CITY OF CAMBRIDGE

BOARD OF ZONING APPEAL

BZA Application Form

LOCATION OF PROPERTY: 35 Webster Ave , Cambridge, MA

1 PROPOSED SOUTH ELEVATION - UNIT 33
1/4" = 1'-0"

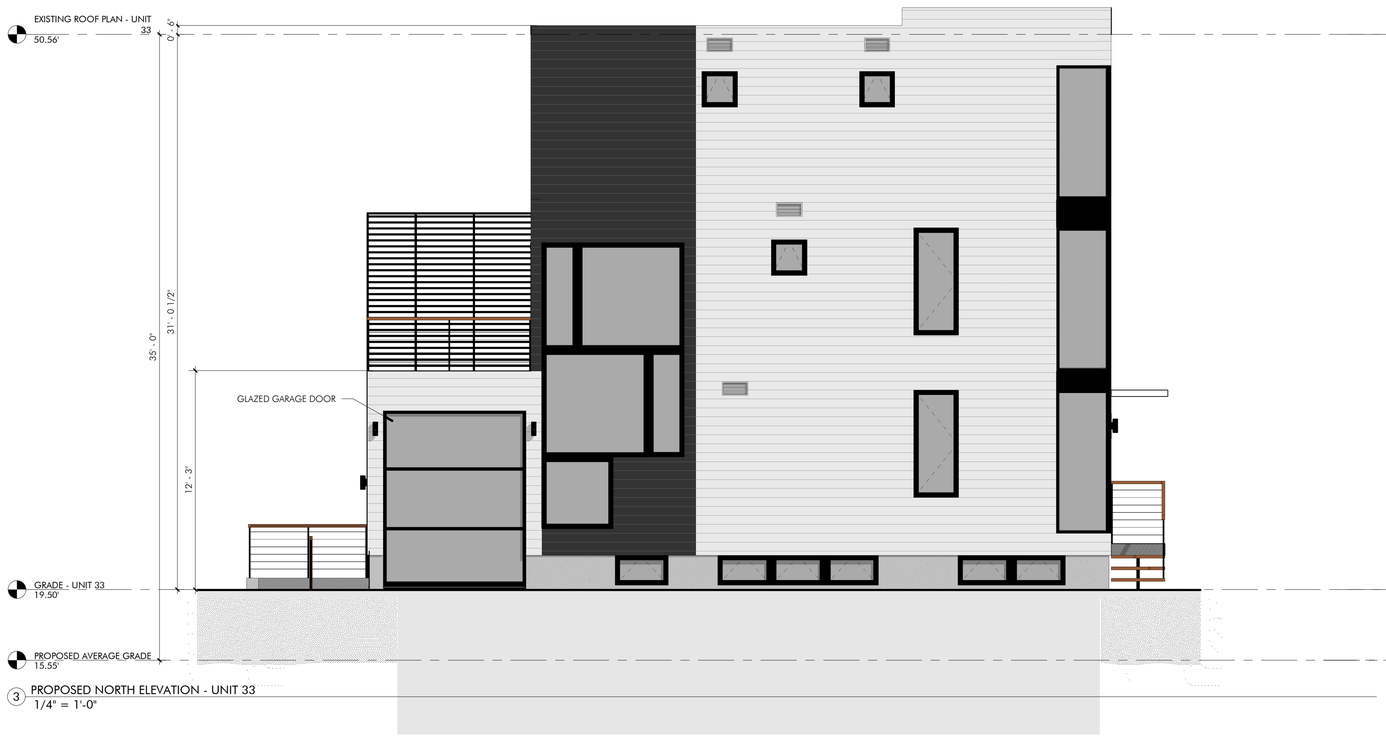
- The proposed SOUTH ELEVATION - UNIT 33 has a 2-story high attachment that acts like a 2-story fence. However, the installation of such an attachment fence poses security dangers to nearby units. In fact, this attachment fence was not present when the developer first presented his plan to us. Therefore, we are opposed to this attachment fence. Such an partially enclosed space is also not clearly defined to be excluded from the GROSS FLOOR AREA.

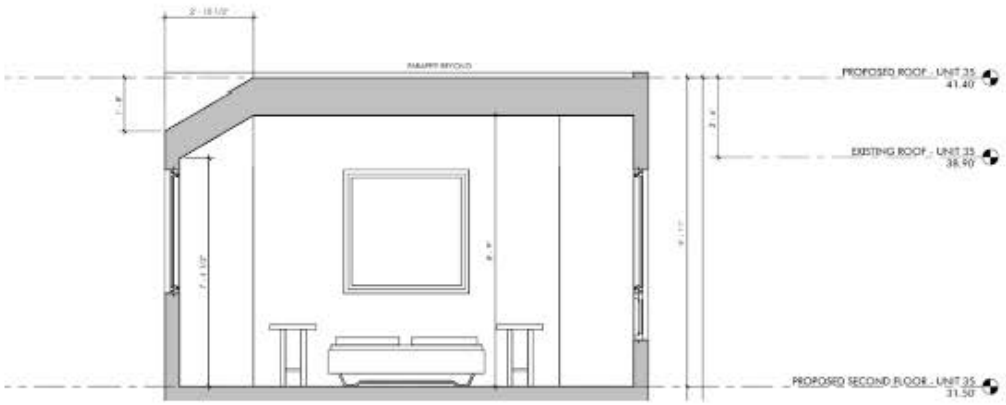
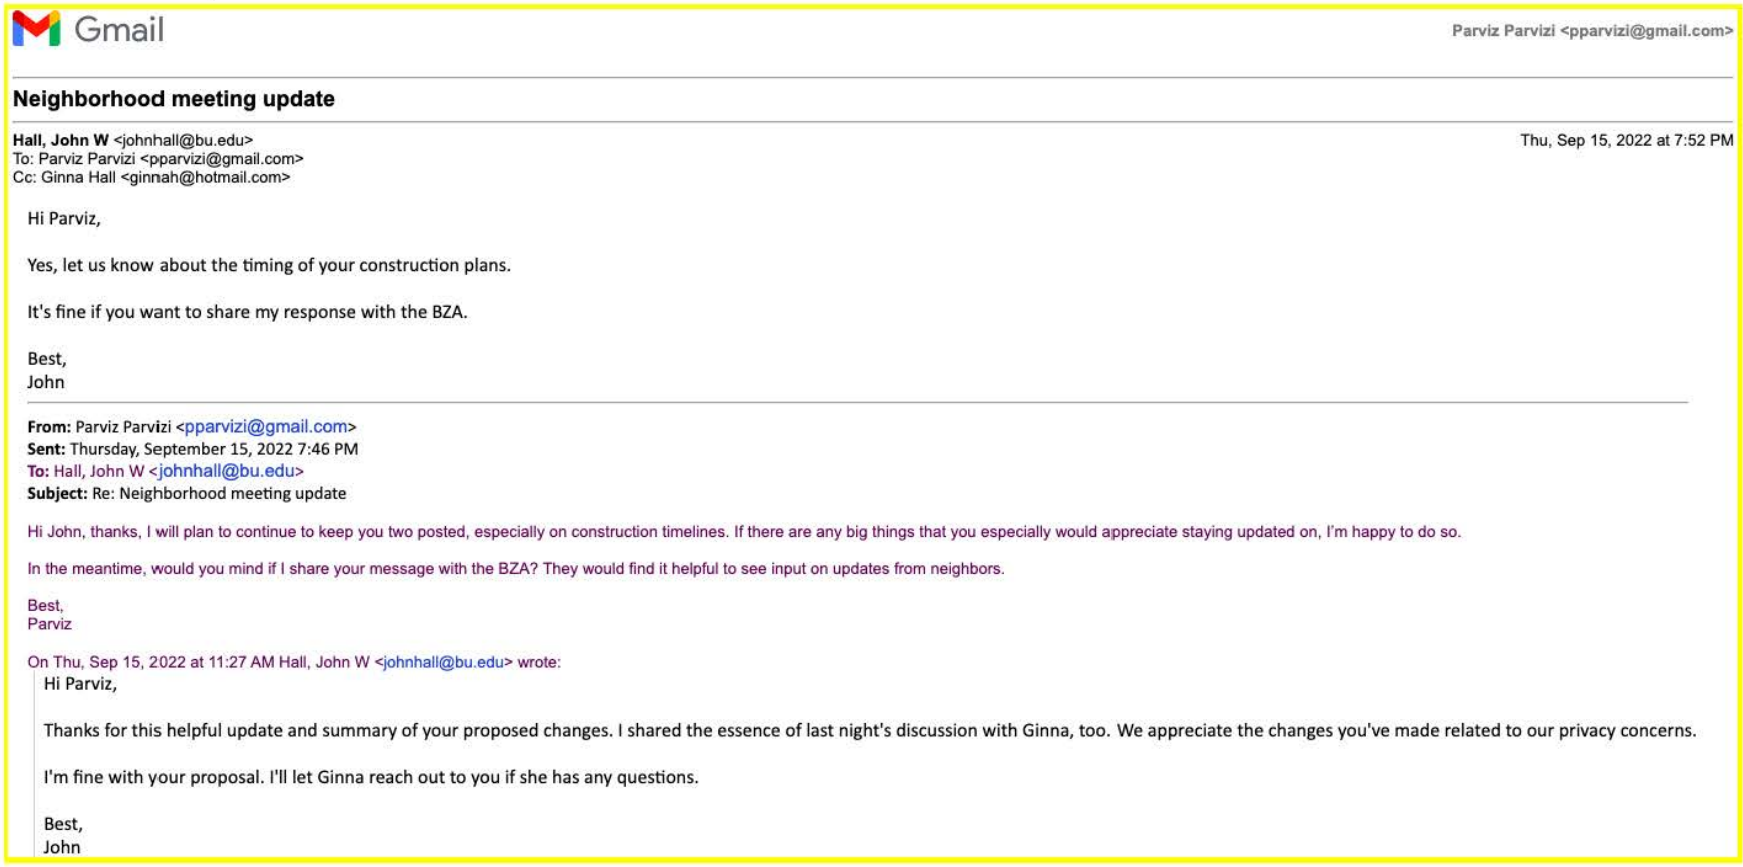
The applicant recently shared a new design with us which reduced the additional shadow impact by
(a) Adopt the sloped roof on the front 12.5' of the house and kept the north eave elevation at 33.67' for that portion.

(b) For the back portion of the north elevation, cutting off a 2'10.5" (width) x 1'8" (height) corner to reduce shadow impact for the 2'6" overall height increase.

And addressed our privacy concerns by re-designing the north facing windows (as shown below)

Overall, we find the new design acceptable for us, thus we are writing this email to express our support to BZA-155115 (35 Webster Avenue).

(b) proposed structure

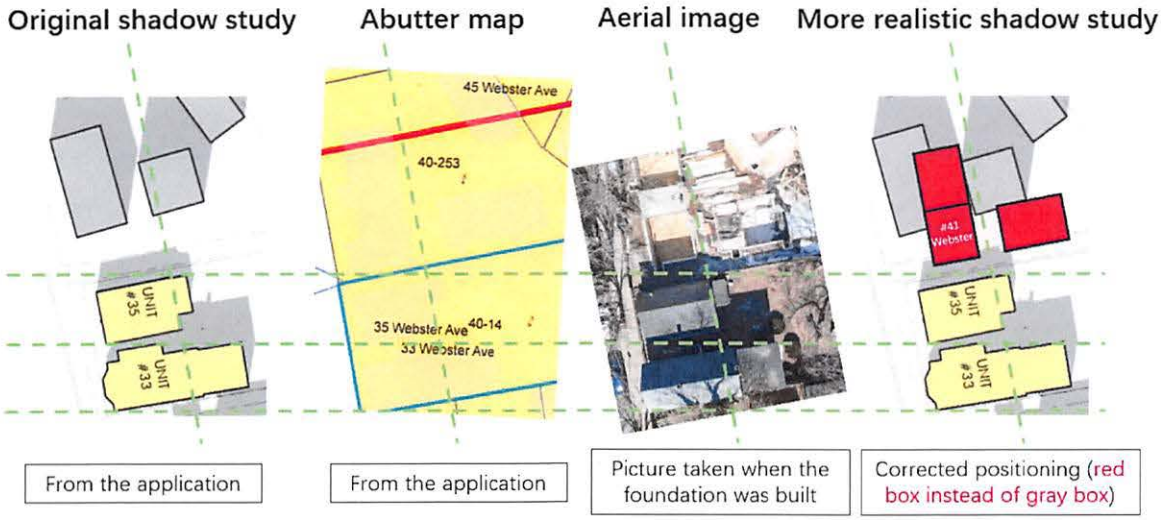
Pursuant to Section 8.22.2(c) of the Zoning Ordinance, the following requirements need to be met before BZA may grant a special permit for the alteration or enlargement of a nonconforming structure.

Shadow of proposed 35 Webster

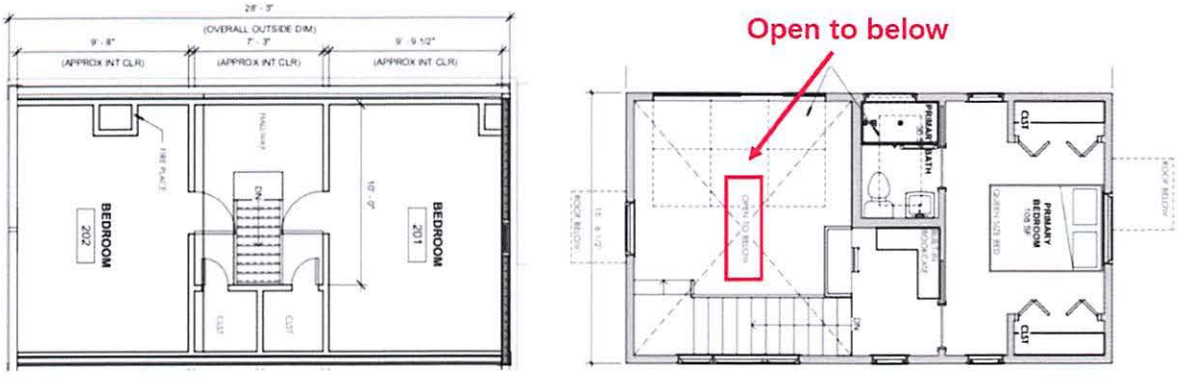
The negative impact will be worse in late fall, winter and early spring when the Sun is lower with an earlier sunset.

Corrected shadow study of the current structure (red boxes indicate correct building locations)

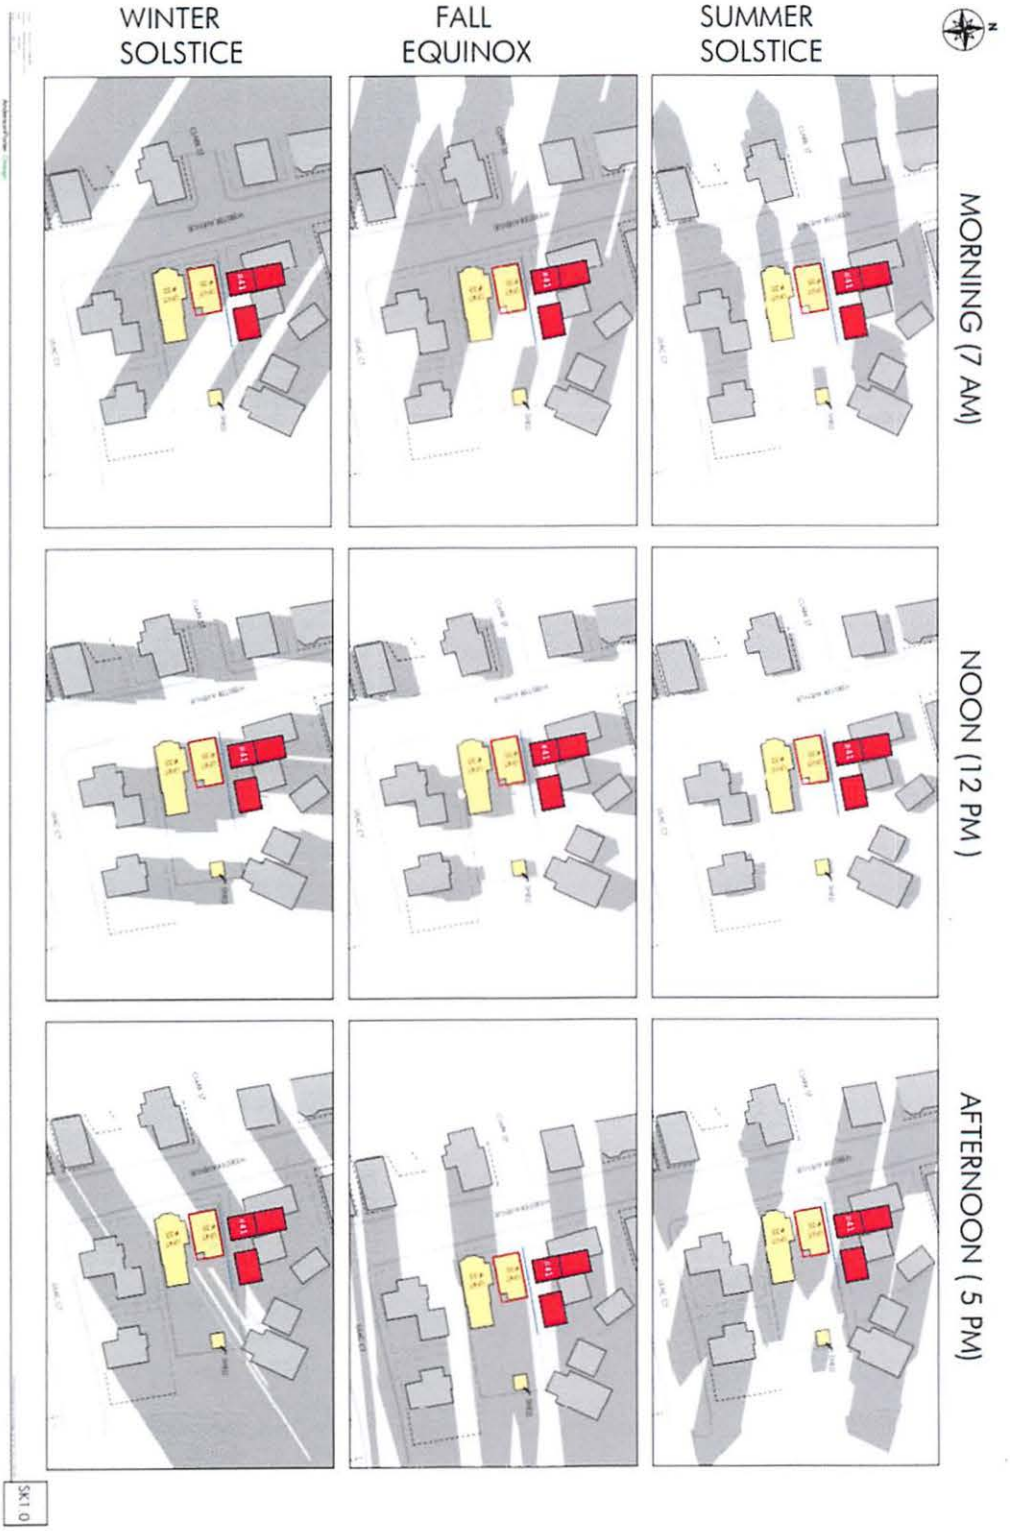
The addition of new openings in non-conforming wall setback also poses privacy concerns as they are directly facing our second floor bedroom windows.

Corrected shadow study of the proposed structure (red boxes indicate correct building locations)

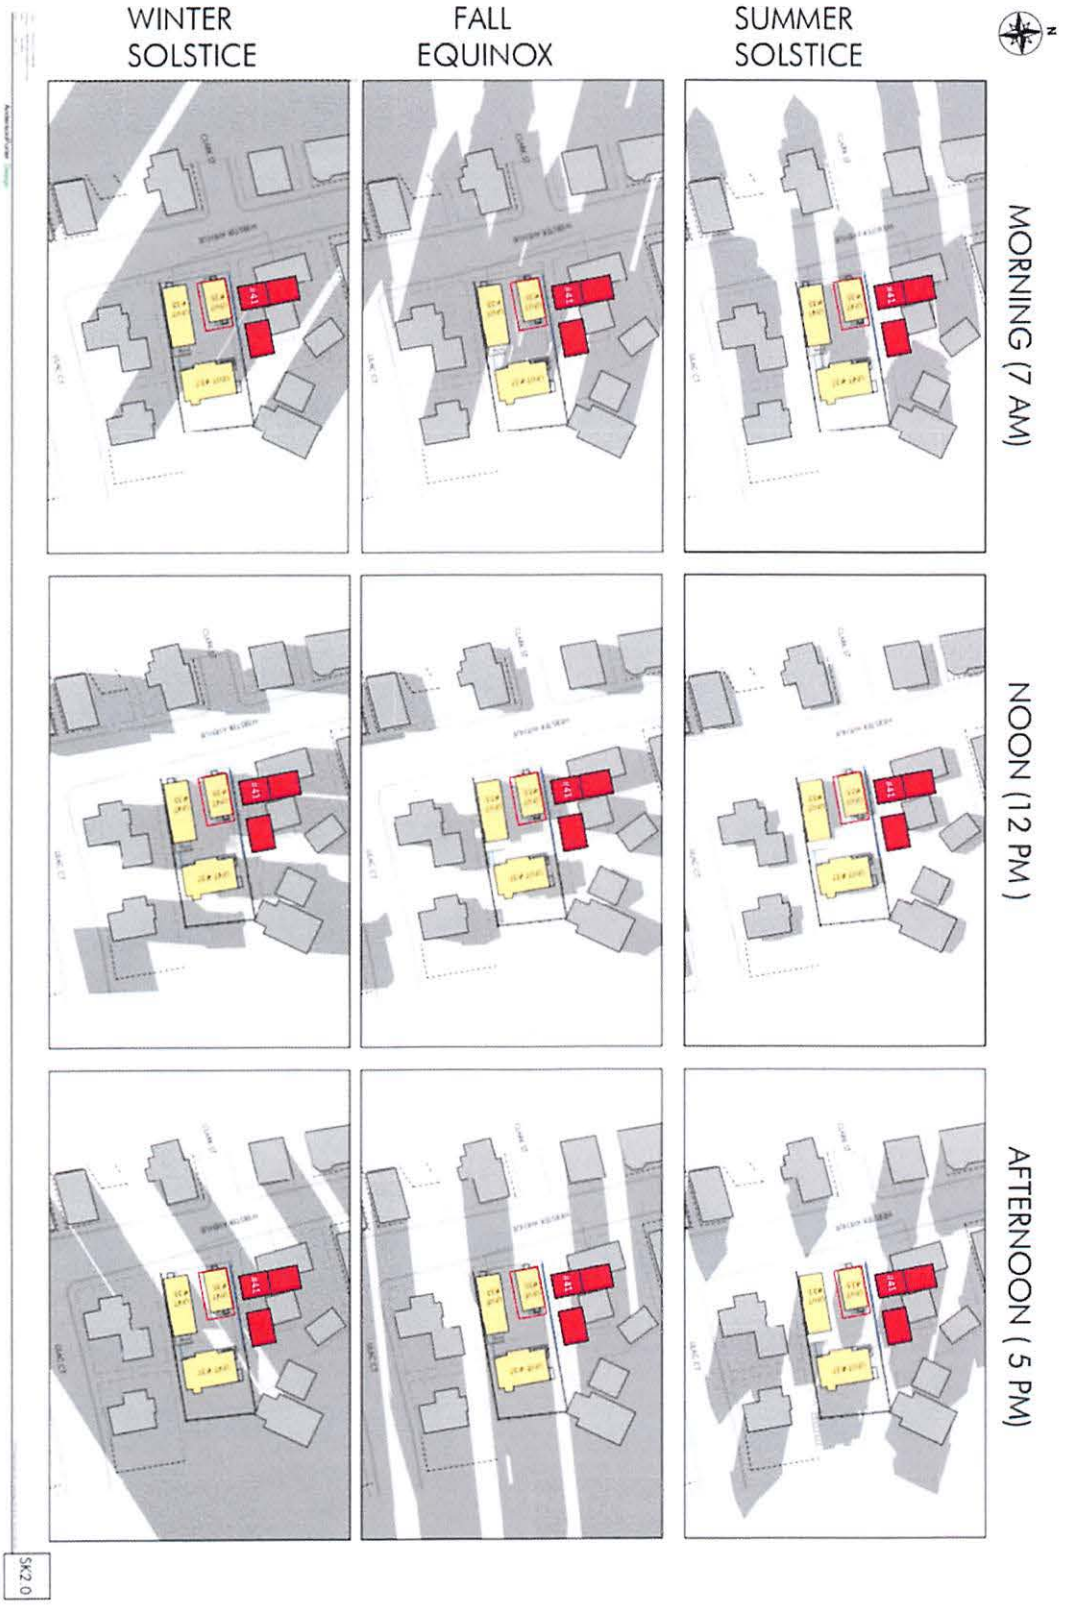
Corrected shadow study of the proposed structure (red boxes indicate correct building locations)
